Land North of 28 to 72 Milton Road, Sutton Courtenay, Oxfordshire

P13/V0401/0
APPENDIX 1

**TECHNICAL NOTE - RESPONSE TO THIRD PARTIES
LAND NORTH OF 28 TO 72 MILTON ROAD, SUTTON COURTENAY
PLANNING APPLICATION REF: P13/V04/01/O
APRIL 2013
OUR REF: AB/TR/NO/20430**

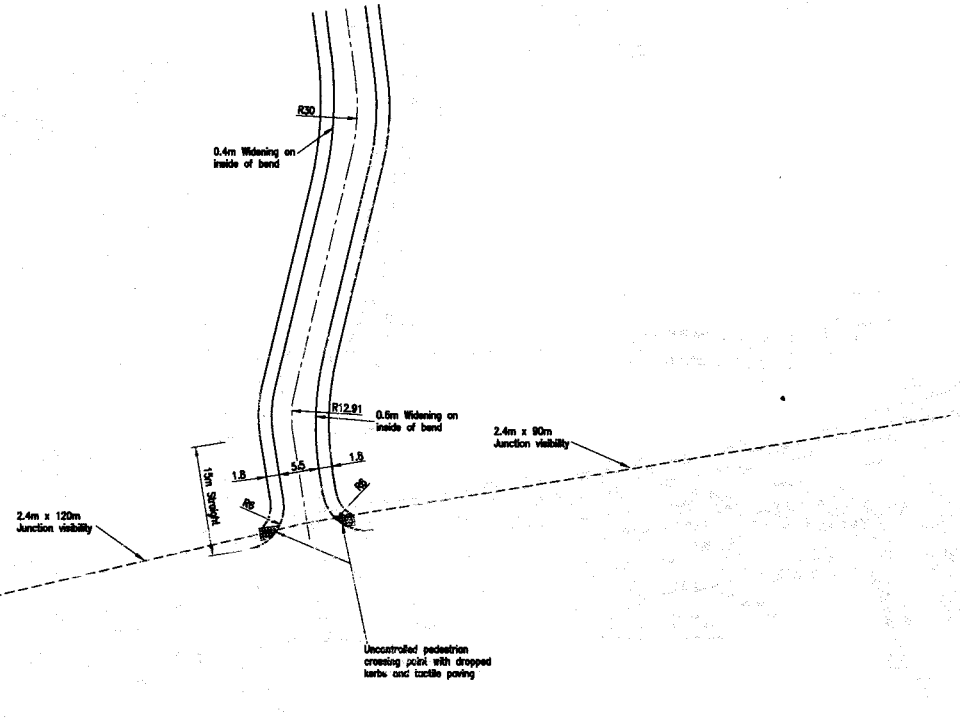
Safety of proposed access location

- Junction spacing
- School buses
- Speeds

2. The Parish Council would question the safety of the access point into the site. It is located close to the Katchside turning, and there would be reduced visibility owing to school buses which stop and collect and deliver children from schools. The Council believes that good visibility would be difficult to achieve. The statistics lodged with the application, confirm speeding in this section of Milton Road.

A		Carnageway widened to 5.5m		JP	TR	18.04.13
REV:	AMENDMENTS:	DRN:	CHK:	DATE:		
PROJECT:						
LAND NORTH OF 28 TO 72 MILTON ROAD, SUTTON COURTENAY OXFORDSHIRE						
DRAWING TITLE:						
PRELIMINARY DEVELOPMENT ACCESS LAYOUT						
CLIENT:						
REDROW HOMES SOUTH MIDLANDS						
DRAWING NUMBER:						
20430_03_003						
REVISION:	SHEET SIZE:	DATE:				
A	A2	14.01.13				
DRAWN BY:	CHECKED BY:	SCALE:				
PT	TR	1:500				
MEC		Wellington House Leicester Road Ibstock Leicestershire LE167 6HP T: 01530 264 753 F: 01530 588 116 ibstock@mecc.co.uk www.m-ec.co.uk

The proposed access junction is located approximately 75m away from the Katchside junction on the opposite side of the road. The Oxfordshire County Council Design Guide states a distance of 60m should be provided and therefore this standard is achieved.

Good visibility is achievable from the proposed access junction with 2.4 x 90m and 2.4 x 120m outlined on the access design included as part of the Transport Assessment. These standards are set against the requirements outlined in Design Manual for Roads and Bridges (DMRB) rather than Manual for Streets and are therefore considered to be robust. The highest recorded 85th percentile speed is 38.2mph which equates to 62kph and using TD 41/95 visibility splay requirements of between 90m and 120m are required.
